Access Compliance Report Public Rights-of-Way (Curb Ramps)

Main Street: CECIL_PASTURE_RD Cross Street: CECIL_PASTURE_RD Location: SW

ADA ID: RPRK211026124007 Ramp Type: Type 6 - Directional 1 Initial Pass/Fail: Pass Overall Compliance: No Severity Score: 5

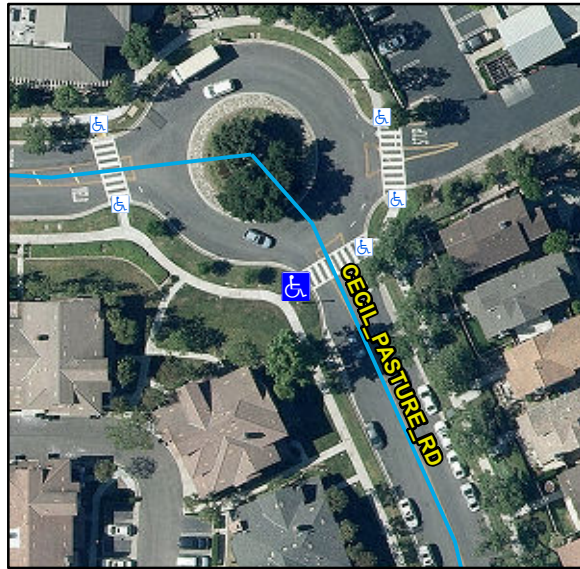
Remove & Replace Entire Ramp. Remove & Replace Gutter.

R304.5.2, R304.5.4, STD 1115
